**Subject: SAFETY RECALL CAMPAIGN 0113 ADDENDUM**

M-1151A

Safety Recall Code 0113

## MAIN CIRCUIT BREAKER REPLACEMENT

**Figure 1. Upper Frame Crossmember (Under Seat)**

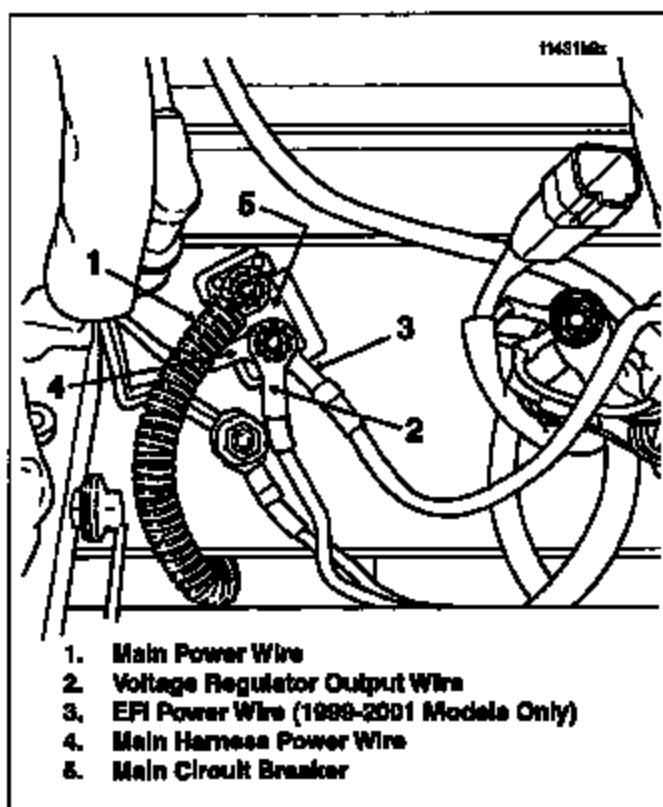
5. Locate main circuit breaker on left side of upper frame crossmember. See Figure 1.
6. Remove Keps nut from copper post. Remove main power wire ring terminal (with convoluted tubing).
7. Remove Keps nut(s) from silver post. Remove voltage regulator output, EFI power (1999-2001 models only) and main harness power wire ring terminals.
8. Bend tab on mounting clip outward and remove main circuit breaker.

1. Install new 50 amp main circuit breaker into mounting clip oriented with the copper post topside. See Figure 1.
2. Install main harness power, EFI power (1999-2001 models only) and voltage regulator output wire ring terminals onto silver post. Start Keps nut on post.

Install only upper Keps nuts on silver and copper posts. Discard lower Keps nuts wherever the previous configuration was double nutted.

3. Place main power wire ring terminal (with convoluted tubing) onto copper post and start Keps nut.
4. Alternately tighten Keps nuts to 20-35 in-lbs (2.3-4.0 Nm).
5. Place the battery into the battery box, terminal side forward.
